Final Environmental Impact Report
East Whisman Precise Plan Project

SCH# 2017082051

TABLE OF CONTENTS

9. Height Exceptions Near Middlefield Station: General Height Standards (Section 3.3.1)

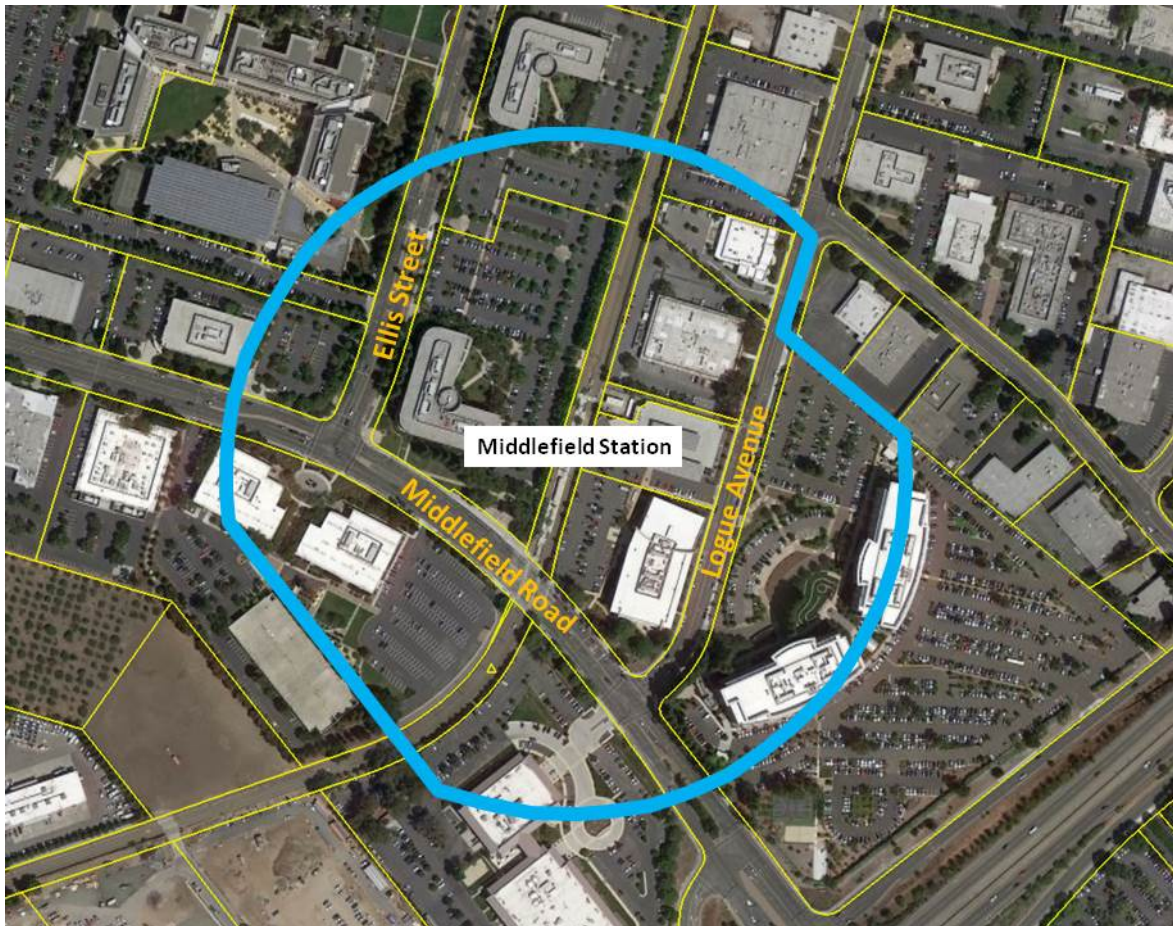
Projects within 750 feet of the Middlefield Station, except within 200 feet of the Precise Plan boundary, may be allowed up to 135 feet with the following additional requirements:

- Consistency with the Moffett Field Comprehensive Land Use Plan (CLUP)
- Buildings must include ground floor neighborhood commercial
- Projects must include high quality open areas
- A range of building heights must be provided
- Tall buildings must be separated by 100 feet
- Facades may not exceed 190 feet in length

Environmental Conclusion: Since the allowed height is increasing from 95 feet to 135 feet, text edits are included in Section 5.0 of this Final EIR to address this change. Projects would still be subject to overall areawide square footage caps and other development standards; therefore, no new or more severe environmental impacts would occur and no additional EIR analysis required beyond the additional text provided in Section 5.0.

Figure 25
Middlefield Road (looking west)

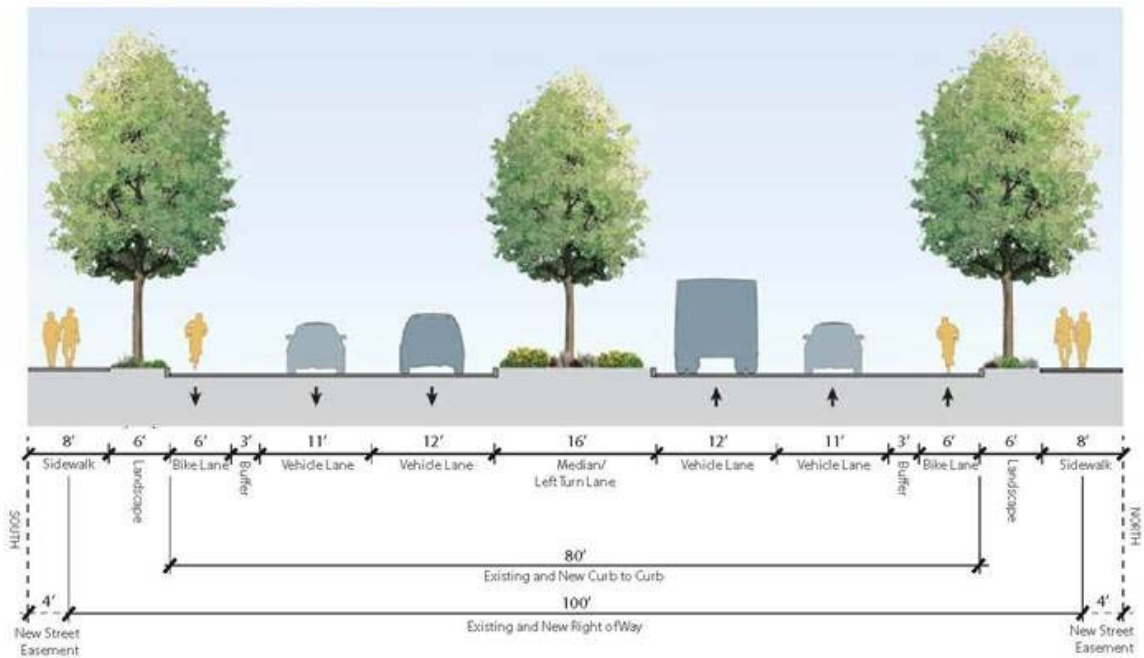
- 4. When I met with the developer, I was told the existing trees on Middlefield Road would all need to be removed because of the way the new sidewalk will be built. Can you please provide more details about how the new sidewalk will affect these existing street trees? Can the loss of trees be mitigated in any way?**

The current sidewalk is a “monolithic” sidewalk, located immediately next to the street/curb line. The existing street trees are generally located close to the back of the existing sidewalk. The project will construct the draft EWPP street design standards for Middlefield Road (see below), which are intended to improve walking and biking conditions. Many of the existing trees conflict with the new sidewalk and public utility easement areas. City staff has closely reviewed options to preserve existing trees. As part of that review, the City Arborist analyzed the condition of the existing trees along Middlefield Road and determined it would be better to remove the existing trees and install new trees. The project will include replacement tree plantings.
